SUNNYBROOK HEALTH SCIENCES CENTRE SHSC OR3 & OR4 LEAD INSTALLATION

RFT NO. CW22886

ADDENDUM 01-R1

Issued: March 17, 2025

Scale	As indicated
Project No.	HS1024-0008
Drawing No.	A20-02 R1

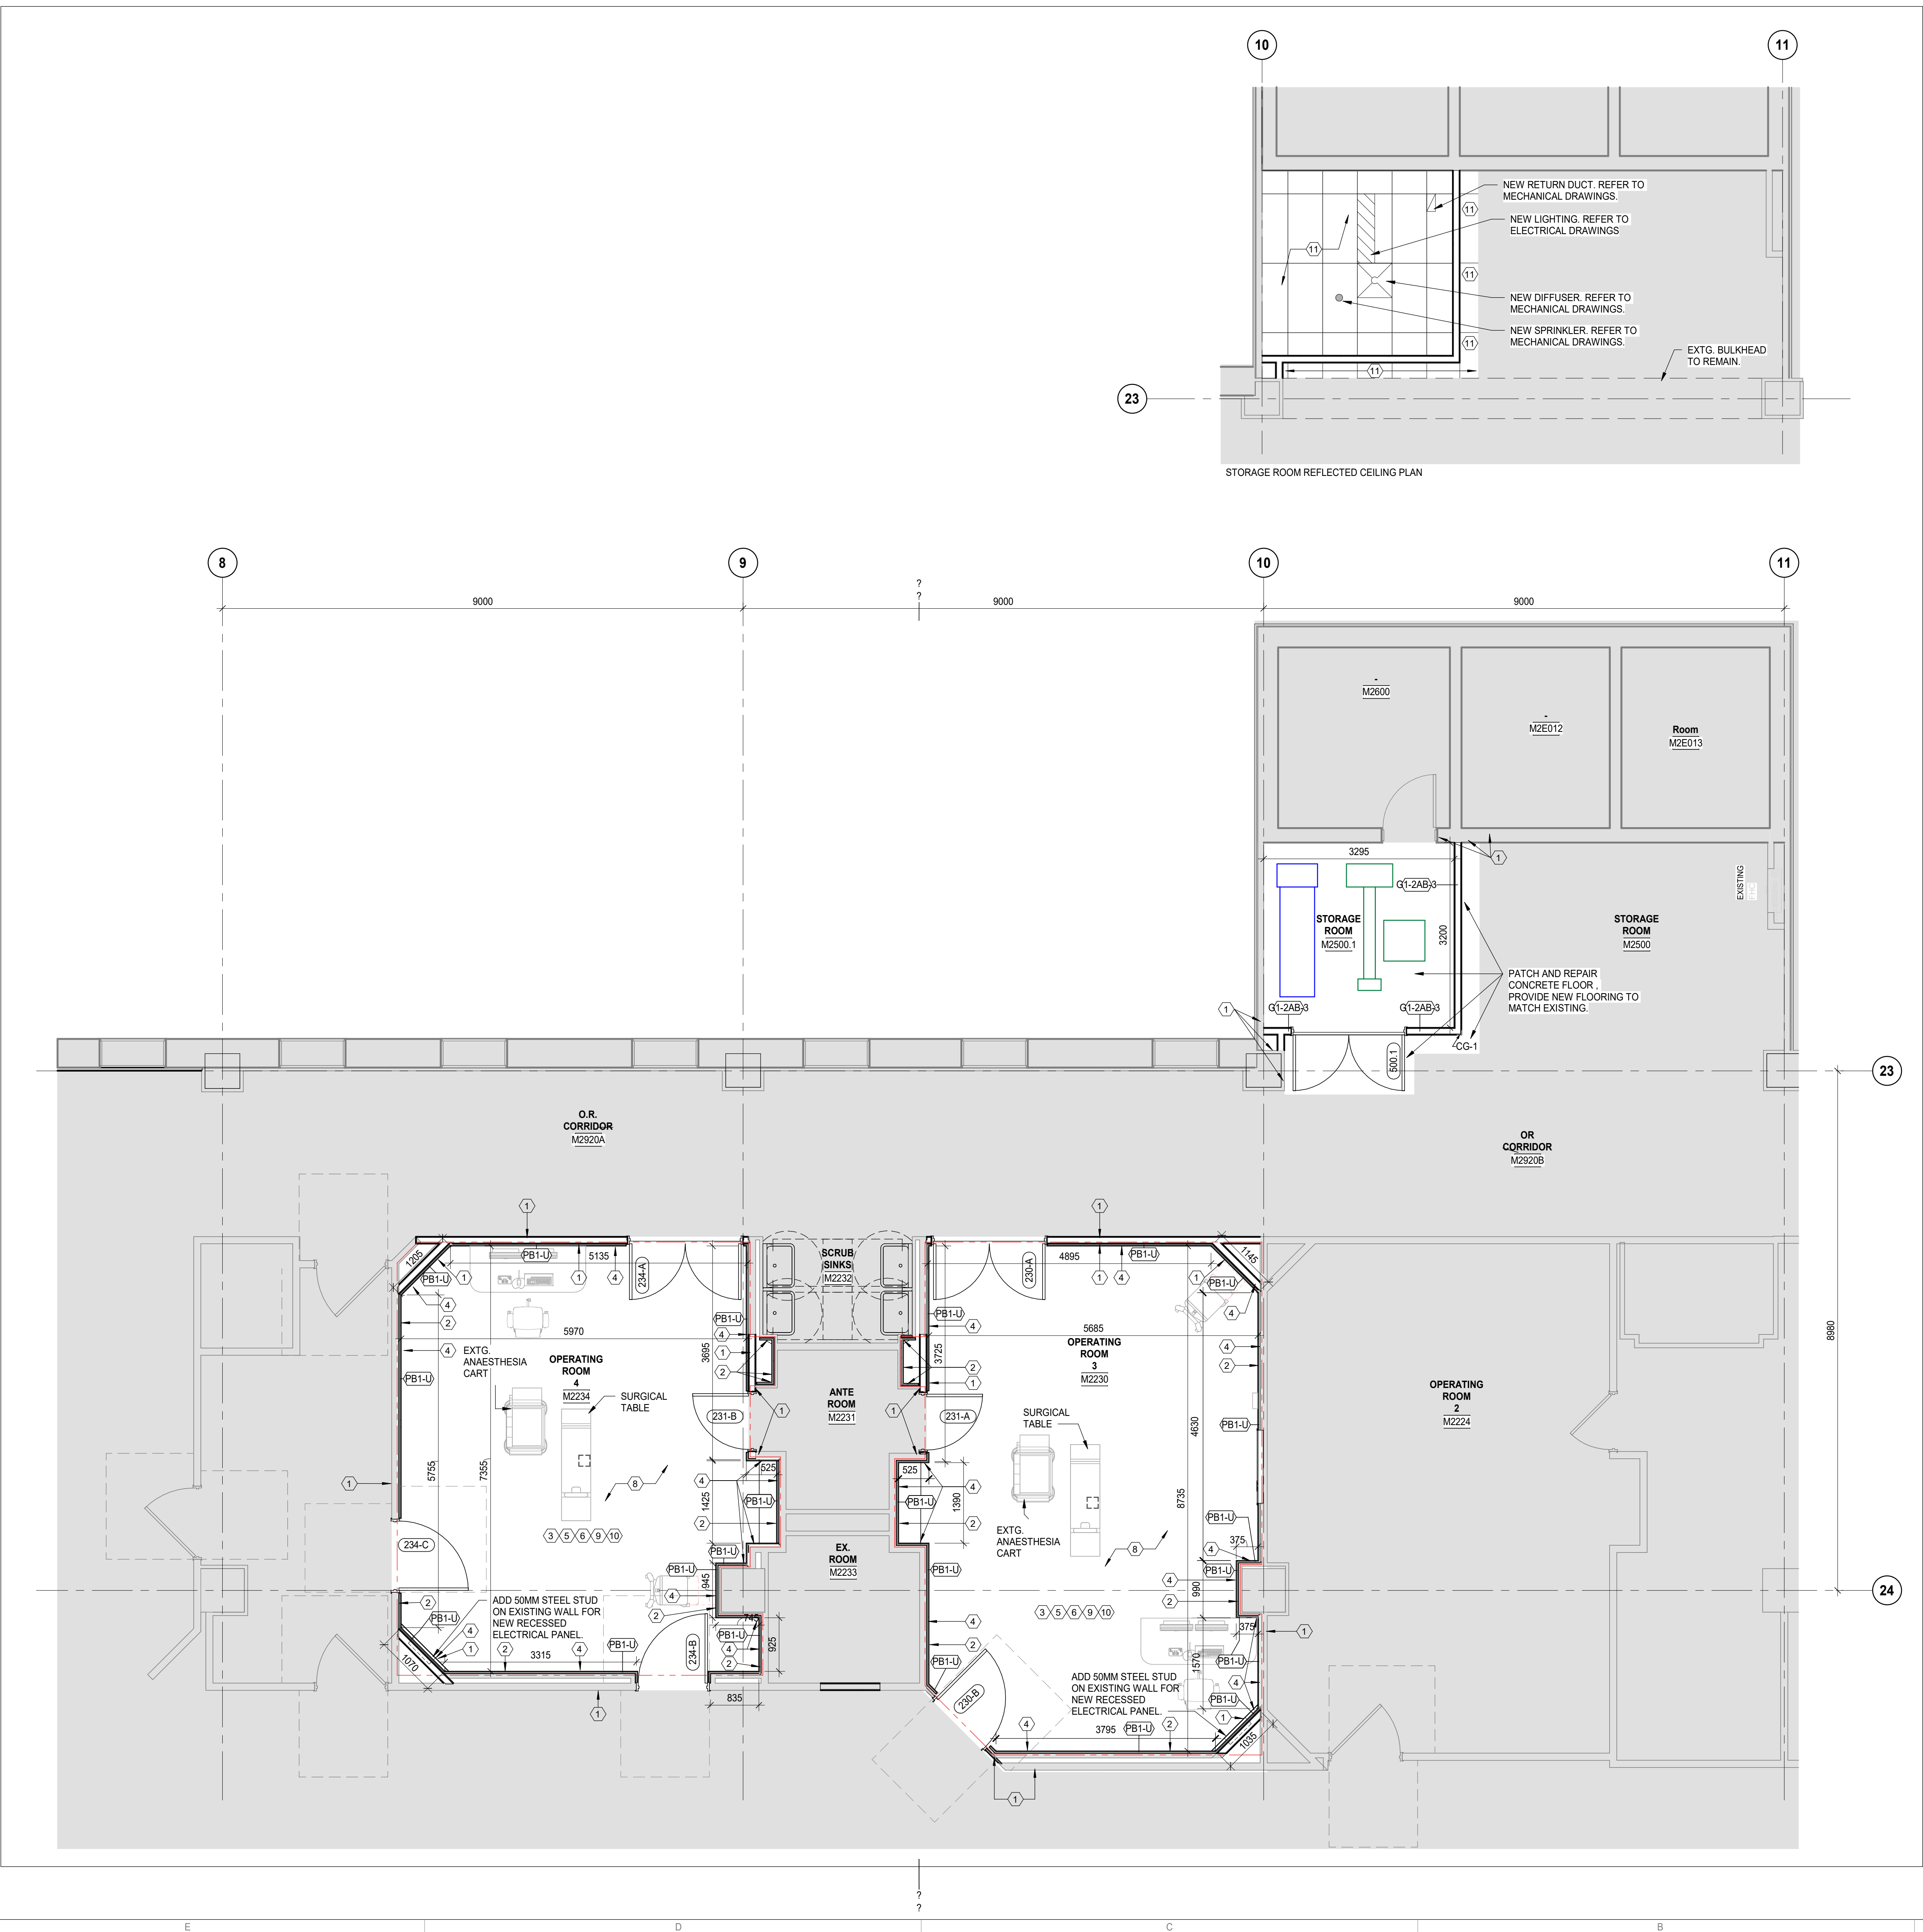
- .1 The following Drawings are revised and re-issued with this addendum. Revisions are shown in bubbled areas on drawings. The following descriptions of revisions are for convenience only and do not define or limit the extent of actual revisions indicated on drawings:
 - .1 Drawing No. A01-0 R1
 - .1 Deleted duplicate information.
 - .2 Drawing No. A20-02 R1
 - .1 Clarification on wall protection.

- .8 Q. Drawing A20-01 note 3 calls for removal of wall protection. Please clarify if new wall protection is required, and if so, please specify all wall protection items required.

- .1 Refer to note 4 in drawing A20-02R1 and specification section 10 26 23. All walls in OR 3 and 4 to receive new wall protection, full height to u/s of ceiling.

- PATCH AND REPAIR EXISTING FLOORING IN THE ENTIRE OR 3 AND 4. SELF-GRAVE BASE TO EXTEND 150mm UP THE WALL.
 - PROVIDE NEW WALL PROTECTION TO ALL WALLS INSIDE OR3 AND OR4. FULL HEIGHT.
